**CITY OF AUSTIN**  
**Board of Adjustment/Sign Review Board**  
**Decision Sheet**

**CASE NUMBER:** C15-2010-0134

**ADDRESS:** 12912 PARK DR

**VARIANCE REQUESTED:** The applicant has requested a variance to decrease the minimum side yard setback requirement of Section 25-2-492 (D) from 5 feet to 4.46 feet along the west property line in order to maintain a garage for a single-family residence in an "SF-2", Single-Family Residence zoning district. Board Member Jeff Jack for discussion only to Grant, Board Member Leane Heldenfels second. The public hearing was closed on Board Member Bryan King to GRANT, Board Member Jeff Jack second on a 7-0 Vote; GRANTED

PROFILE EXHIBIT OF FENCES ON  
COMMON LINE OF LOTS 76 & 77,  
HUGHES PARK SUBDIVISION NO.1  
(PERSPECTIVE IS WEST TO EAST)

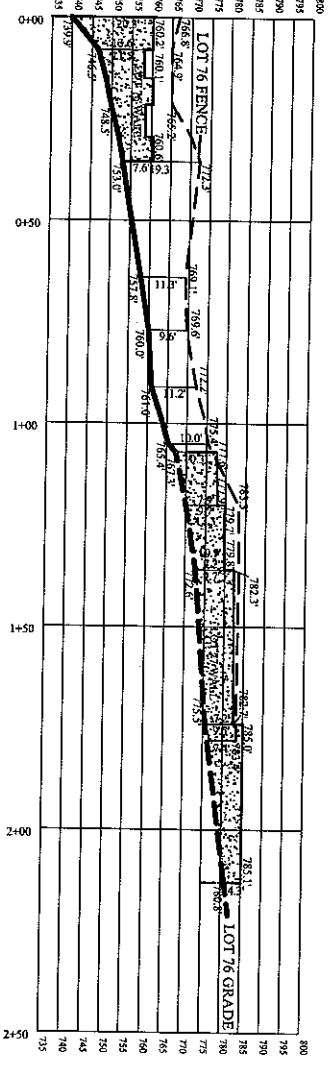
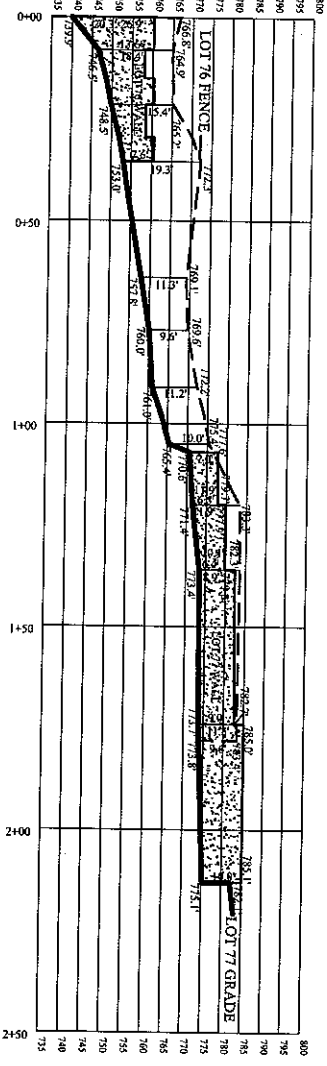
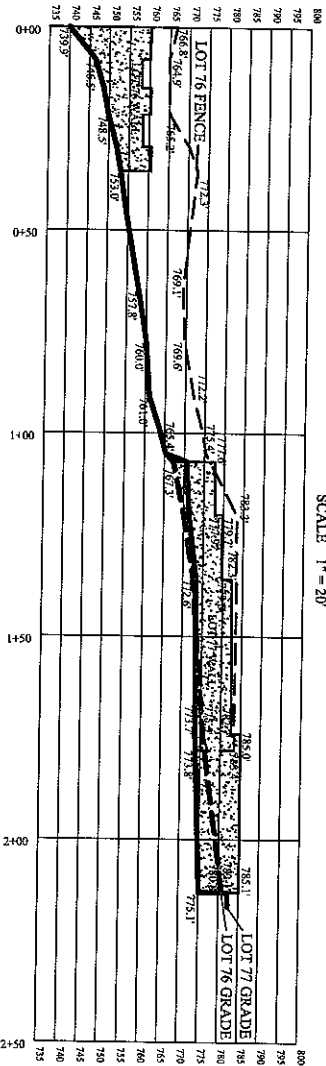
**BOARD'S DECISION: (West side property line)** The public hearing was closed on Board Member Heidi Goebel motion to Postpone to May 9, 2011 to provide additional information clear graphics of the fence and update height variance requested, sealed survey measured on both sides, Board Member Jeff Jack second on a 7-0 vote; POSTPONED TO MAY 9, 2011. (RE-NOTIFICATION REQUIRED)

# DECK

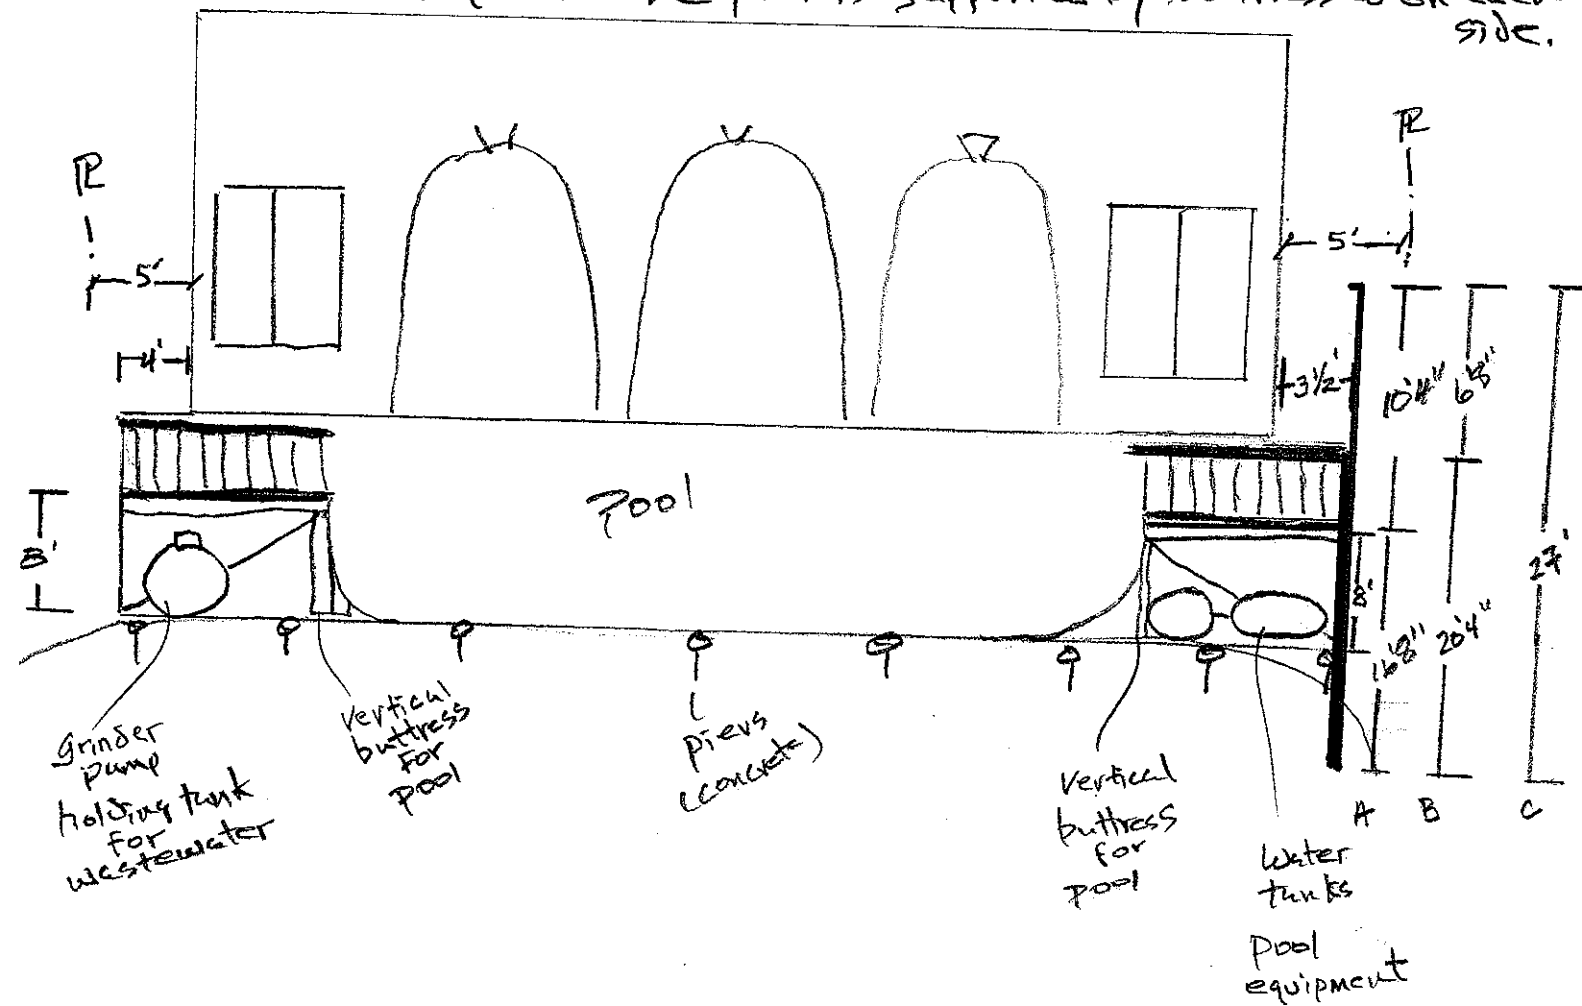
1. The deck extends into sideyard  $3\frac{1}{2}$ -4'.
2. The deck is part of the landscaping/hardscape + covers pool equipment on the west side + wastewater package plant, including a grinder pump and wastewater holding tank on the east side.
3. The deck covers the structural support (vertical buttresses) for the pool, pool equipment + sewage equipment.
4. On the west the lot owner has constructed a 27' concrete, iron, wood + sheet-metal wall + fence. The concrete portion of the wall is 20'4" high, (B below); the fence/wall is 27' tall (C below); the wall and fence are 10'4" above the floor ~~level~~ level of the deck (A below). The deck is 8' above the ground.
5. The deck, pool equipment, + structural support are shielded by the concrete wall.
6. The pool, deck extended out over a bluff are supported by concrete piers. The pool is supported by buttresses on each side.

**Fred's Wall getting started - Cut and Built to 15'  
September 2004 – NO PERMIT**

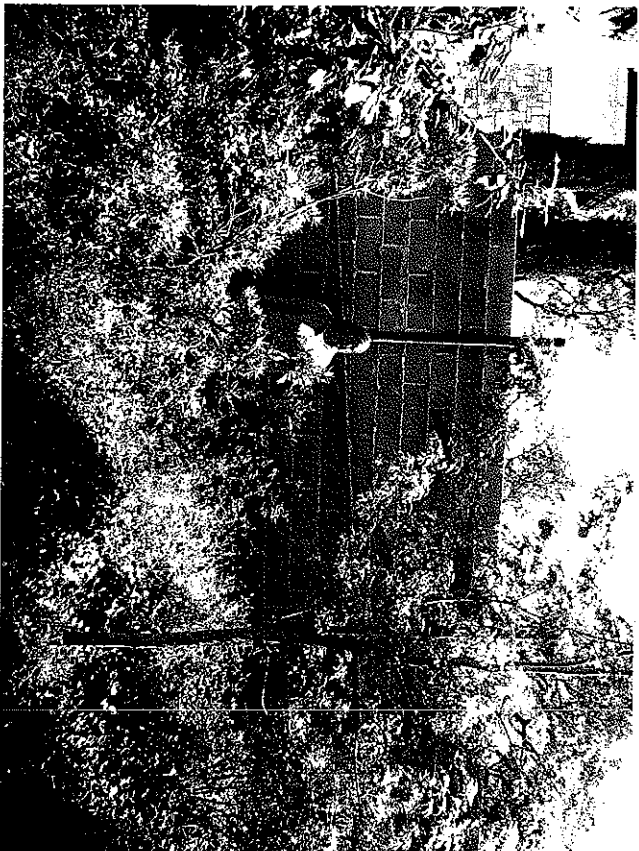
Unfinished on our side ☹️

Note gas line  
above ground!!!

# Our side of his wall

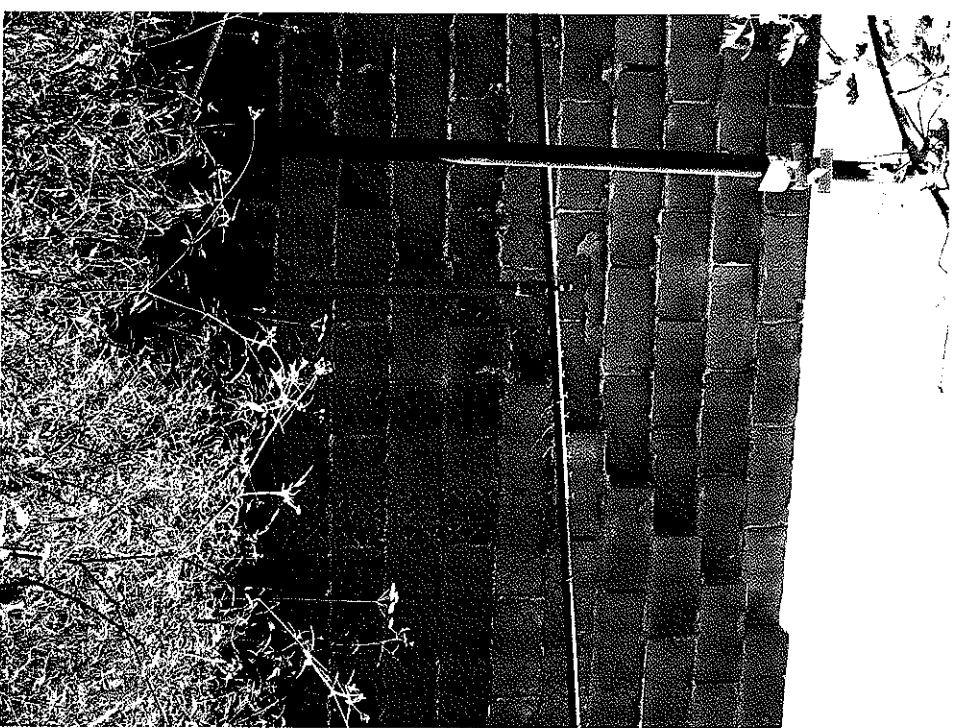
I'm 5'9" tall.

Left unfinished and jagged on purpose

# Fred's two garages – before and after

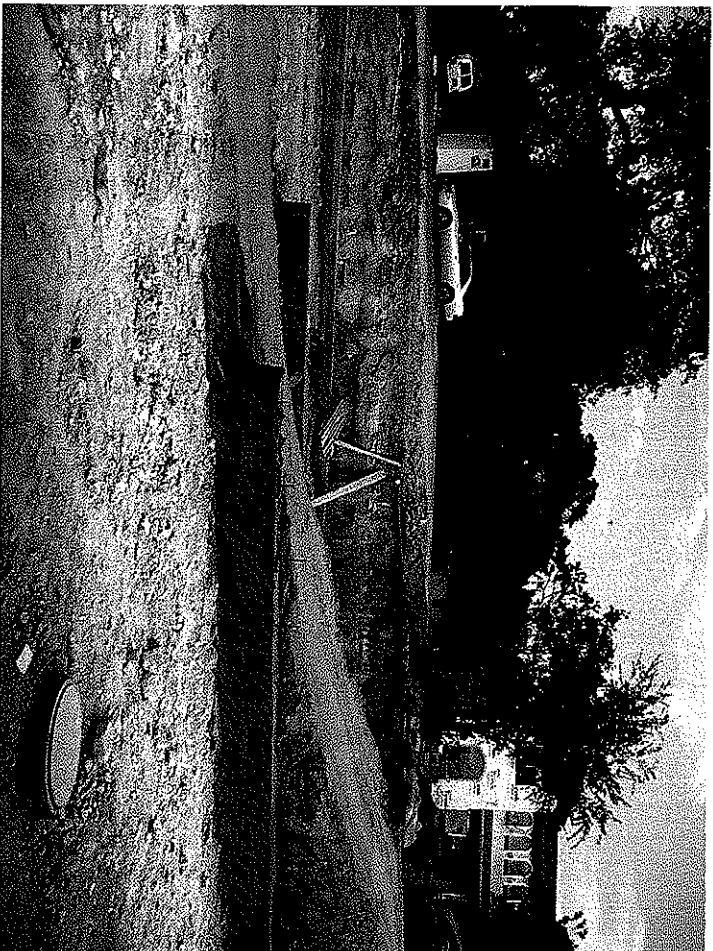
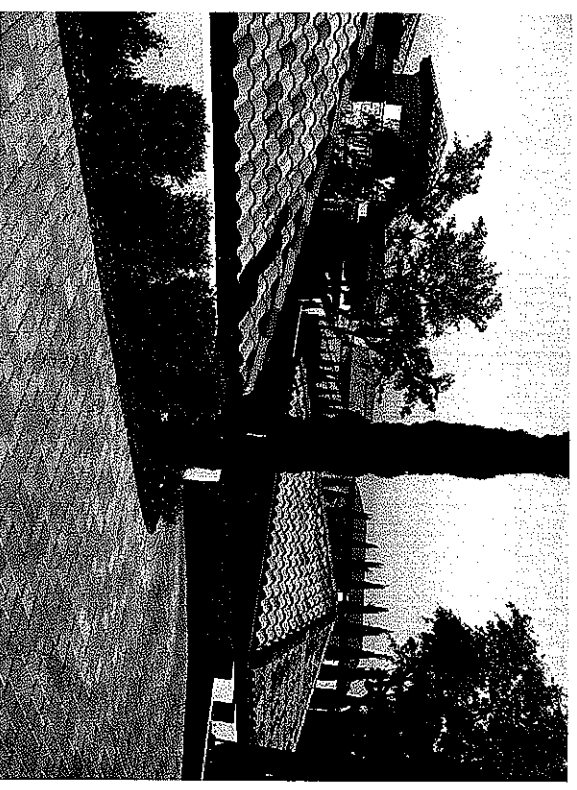
This was at 41%  
impervious cover (max  
45%)

Much more cover  
now!! What %%?

# Roof of his garage

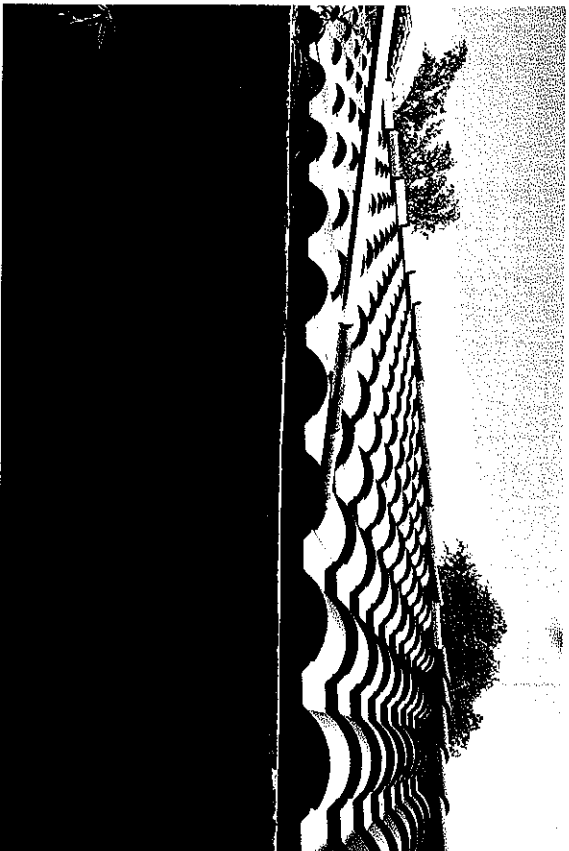
Tiles of garage roof right next to property line

Roof line in setback; view from street
